Form No: 160.00-M4 (LS01)	1002
	Supersedes: 160.00-M4 (LS01) (702)	
LITERATURE SUPPLEMENT	File with: 160.00-M4	
Subject: Variable Speed Compressor Serial Communications Faults

Background

Figure 1 – ACC Board Wiring Changes

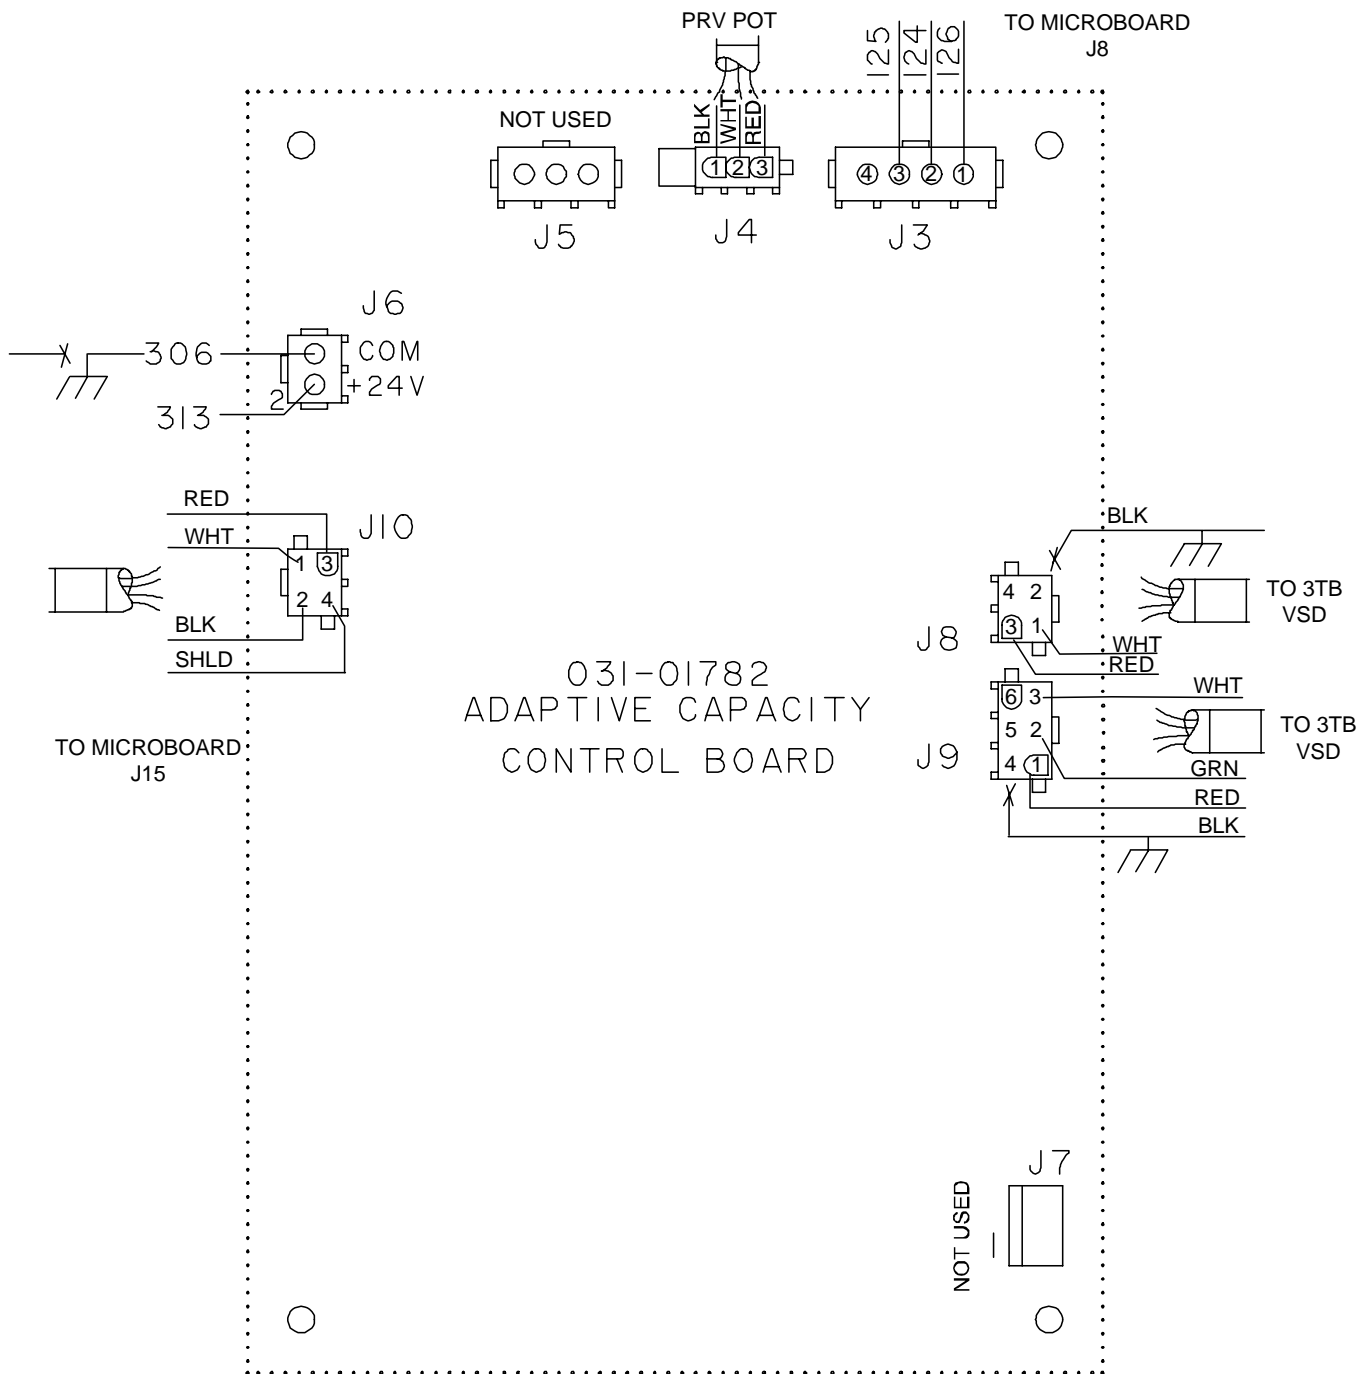
For the following procedures refer to Figure 1.

1. At J6 of the ACC board cut wire 306, 2-½ inches from the ACC board. Tape off the wire end that is not connected to the ACC board. Install a lug on the wire end that is still connected to the ACC board. Drill a hole near the ACC board so this lug can be grounded to the OptiView Control Panel's enclosure. Connect the ground to the enclosure with a self-tapping screw.
2. At J8 of the ACC board remove the black wire insert in pin 2 of J8. Cut off the pin and install a lug on the wire so that it can be connected to the OptiView Control Panel's enclosure. Connect this wire to the enclosure where the shield of J8 is connected.
3. If the Harmonic Filter is not installed, then remove the connector installed in J9. This cable should be tied back so that it is not accidentally reinstalled at a later date.

If the Harmonic Filter is installed, then remove the black wire insert in pin 4 of J9 on the ACC board. Cut off the pin and install a lug on the wire so that it can be connected to the OptiView Panel's enclosure. Connect this wire to the enclosure where the shield of J9 is connected
